# United Village

Appeal of Planning Commission Decisions  
Related to  
Hotel and Parking Garage Project

April 10, 2024 - City Council Meeting

Zoning File #24-022-766

# Variance #3 – Entrance Drive along University

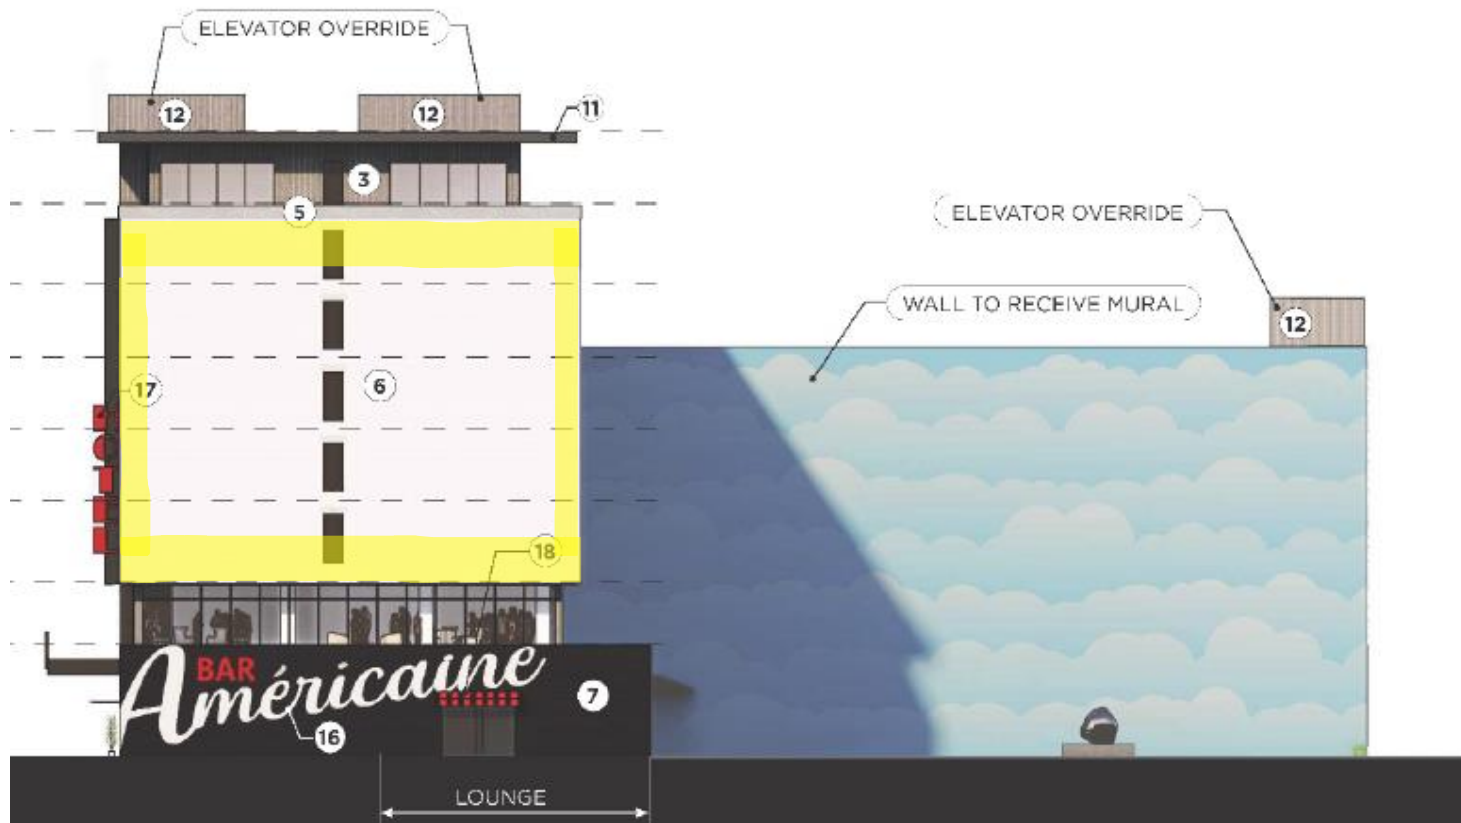
- Zoning Code limits driveway to 60' of lot frontage and 322' proposed for a variance of 262'
- Controlled access
- Utility boxes on University
- Side street access
- One-way westbound
- Drop-off/pick up lane
- Bypass lane
- No parking/No Not Enter Signs

- a) Entrance drive is vehicle-focused and does not provide safe and efficient circulation of all modes of transportation, including transit, pedestrian and bicycle traffic and is not in harmony with the Zoning Code.
- b) Entrance drive is contrary to comprehensive plan policies that call for: 1) focus on pedestrians, bicyclists, and transit; 2) high quality pedestrian urban design; 3) pedestrian-friendly streetscapes.
- c) Decision to site the driveway parallel to University Avenue is a choice made by the applicant and does not constitute a practical difficulty.

- a) Direct access from University is not allowed, the driveway is in harmony with the zoning code intent of ensuring convenience of access to property
- b) Comprehensive plan policies call for 1) minimizing and consolidating curb cuts and using side street access and 2) high-quality urban design that supports pedestrian friendliness and enhances the public realm
- c) Access management from county and city policies create practical difficulties as does presence of utility boxes along University

2. The United Village Final Plat shall be approved by the City Council and recorded with the county recorder and/or registrar of titles.
3. The driveway shall be for **one-way westbound** traffic only. Signage shall be installed indicating that **no parking** is permitted in the driveway and that the driveway is for check-in/check-out, pick-up/drop-off, and valet only. Signage shall indicate stopping in the bypass lane is prohibited.

4. The driveway shall be for **passenger vehicles** only as the site design cannot accommodate turning movements for larger vehicles.
5. There shall be a **direct pedestrian connection** between the sidewalk along University Avenue and the primary hotel entrance. The connection shall be reviewed and approved by Public Works.

6. There shall be a **landscape buffer** between the sidewalk along University Avenue and the driveway.
7. There shall be a **sidewalk width of 18'** along University Avenue.

8. The **owner/operator is solely responsible for ensuring the driveway operates in a safe manner for all users and does not result in adverse impacts to the public road system**. If the owner/operator is unable to manage the driveway in a safe manner that avoids adverse impacts to the public road system the City reserves the right to require closure of the driveway access points at the cost of the owner/operator. The owner/operator must at all times maintain an operating plan for the driveway and must provide it to the City upon request. This initial plan must be reviewed and approved by the Public Works Traffic Engineer during site plan review. Specifics to be addressed shall include: 1) document protocols, enforcement, and signage to limit the driveway to passenger vehicles, to manage the bypass lane, to prohibit parking and ultimately to assure no adverse impacts to the public road system; 2) quantify driveway use, frequency, volume, and peak times, etc.; 3) document how Metro Mobility, delivery vehicles, limousines, buses etc. will be accommodated and serve the site without adversely impacting the public road system.

# Variance #5 Conditions – Windows on West Wall of Hotel

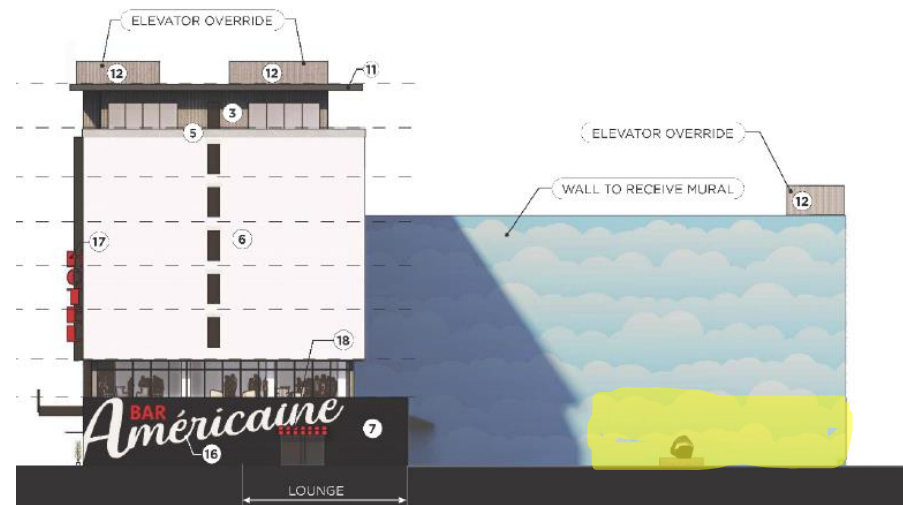
# Variance #5 - West Wall of Hotel Portion of Building

1. Final plans approved by the Zoning Administrator for this use shall be in substantial compliance with the plans submitted and approved as part of this application.
2. The United Village Final Plat shall be approved by the City Council and recorded with the county recorder and/or registrar of titles.
3. A wall graphic and lighting shall be installed on the west façade of the hotel portion of the building; this façade shall be lit at dusk.
4. A mural shall be installed on the west façade of the parking garage portion of the building within one year of the issuance of the certificate of occupancy. The mural shall be lit at dusk.
5. **Additional openings shall be added to the west façade of the hotel building on floors 3 through 7.**
